From: Scala, Mary Joy
Sent: Thursday, August 22, 2013 4:18 PM
To: Kristen Kirkpatrick (kristen@realpropertyinc.com); 'jboyd@hbapc.com'
Cc: 'JOHN M ANDERSON'
Subject: BAR Action 408 E Market Street

Certificate of Appropriateness Application

BAR 13-08-04
408 E Market Street
Tax Map 53 Parcels 54AA and others
408 Condo Owners Assoc, Owner/Real Property Inc., Applicant
Replace roofs, roof decks and roof patio doors

ROOF DECK OF #301 AT 408 MARKET STREET

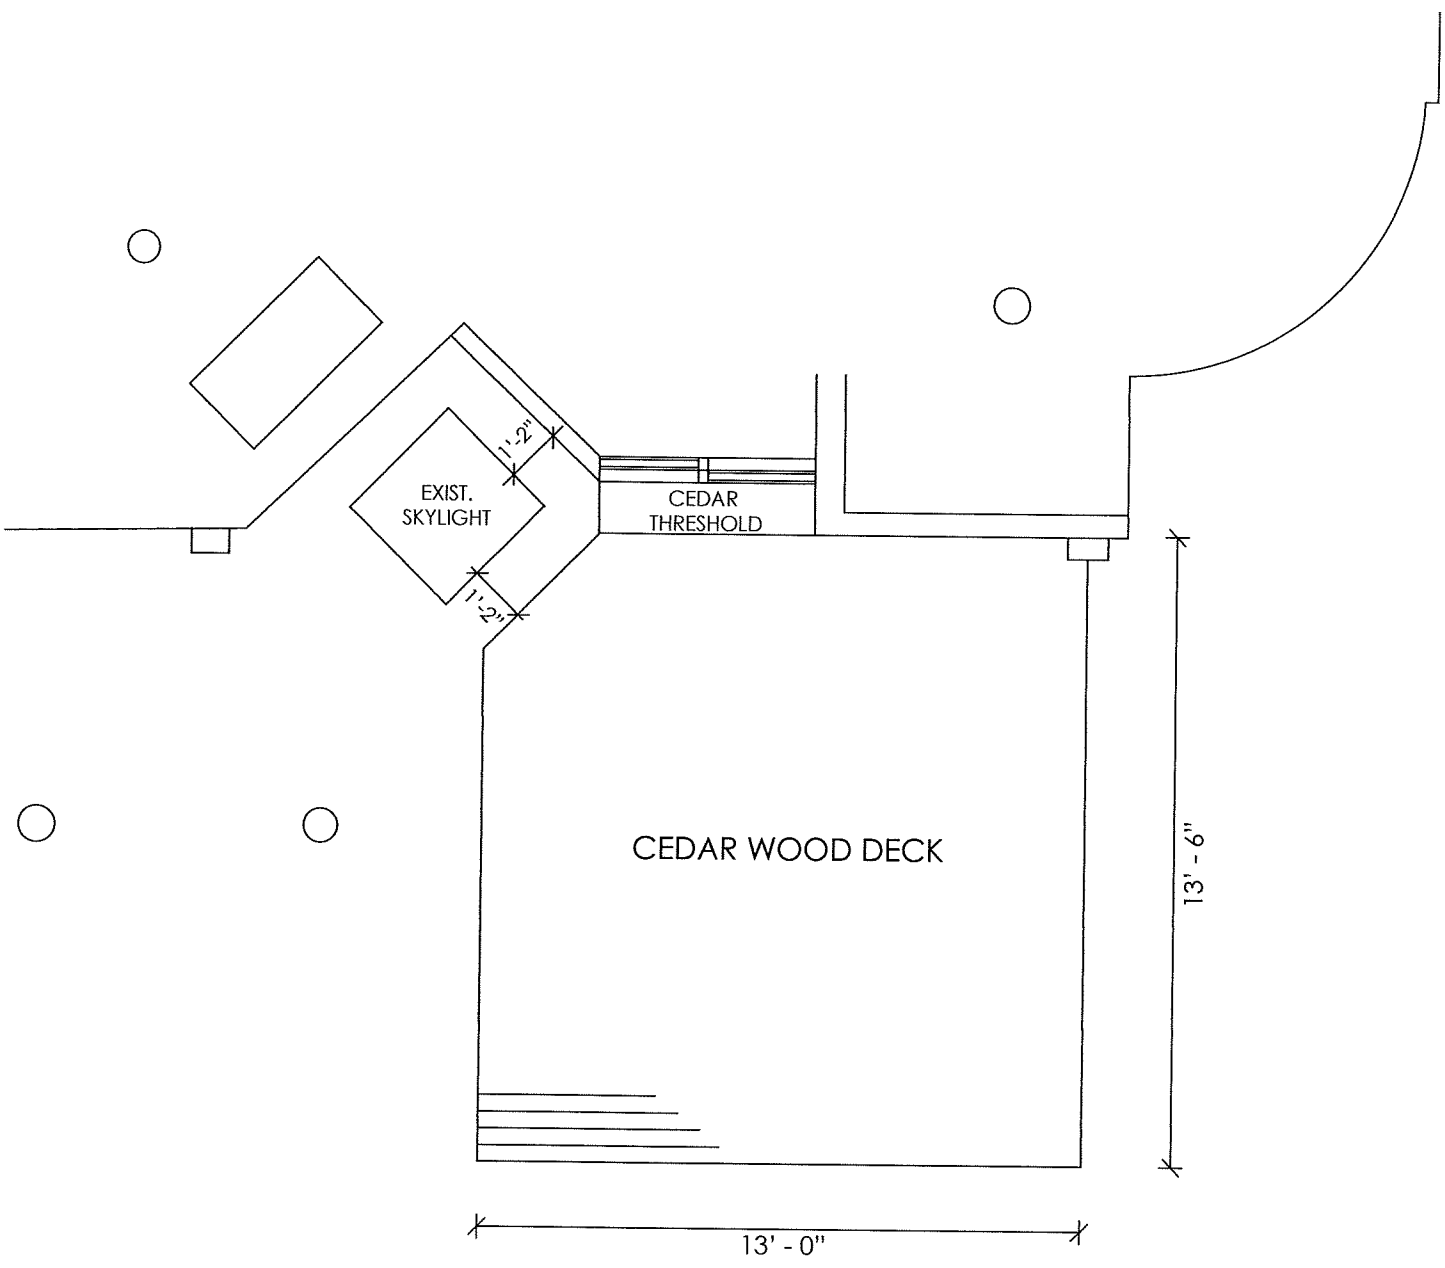
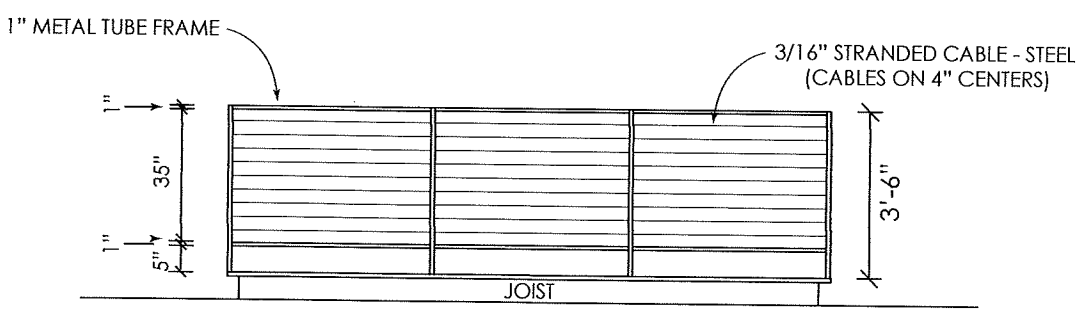
The only thing I see that might help you more is the apartment that wants to add the handrails does not have a deck now.

We are installing the framing for a new deck that never was there before. Deck and rail design I have not seen.

the cable rails are on one other apartment but look added on not original to the building.

Not too late. I assume the cable rail goes around the new deck?

Yes, the cable railing goes all the way around the deck. It matches another roof balcony that is already in place on the southeast corner of the building. Please let me know if you need any more information.

REPLACE COPPER
WALL CAPS +
ANCILLARY ROOFS

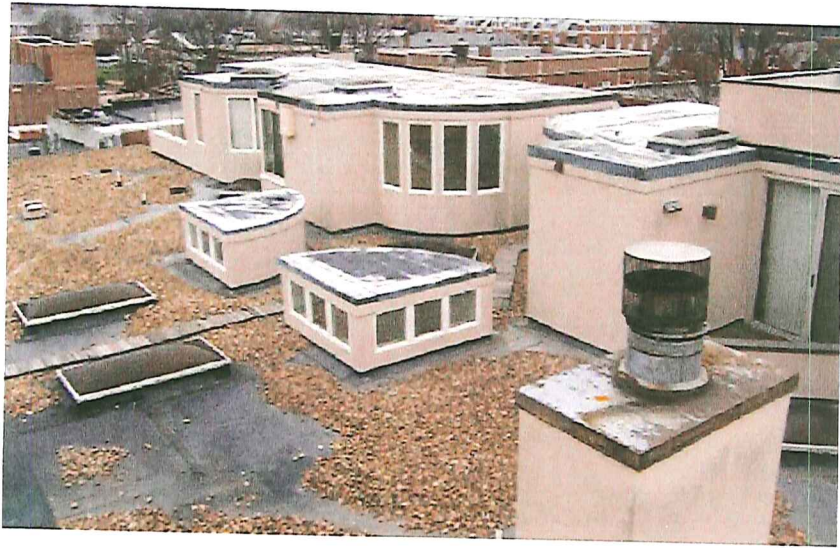
- ❖ The Association does **not** plan to replace any of the mansard roof components on the Market Street elevation. The attached pic shows those copper roof features and the copper wrap that follows the vertical building accents. Those components are not part of the roof replacement project. The wall cap above these roofs will be replaced and flashed into the new membrane (there is no parapet wall there, the cap is flush with the membrane).

MANSARD ROOFS
NOT PART OF
PROJECT
←

Overview of south roof area.

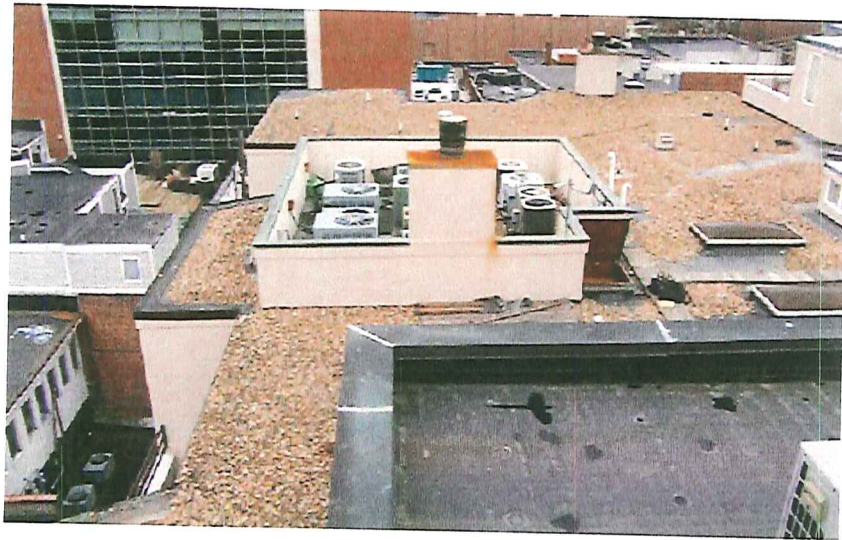
The sleeper rails that support the heat pumps need to be removed and replaced in a new position that doesn't block water from the copper roofs.

Stairway and elevator roofs are raised above the main section.

This stair will need to be removed along with the decking in order for us to properly re-roof underneath. Removal and replacement is not included.

Replacement of wood decking is not included in our budget. Demolition is included since it will be necessary to do so for roof replacement.
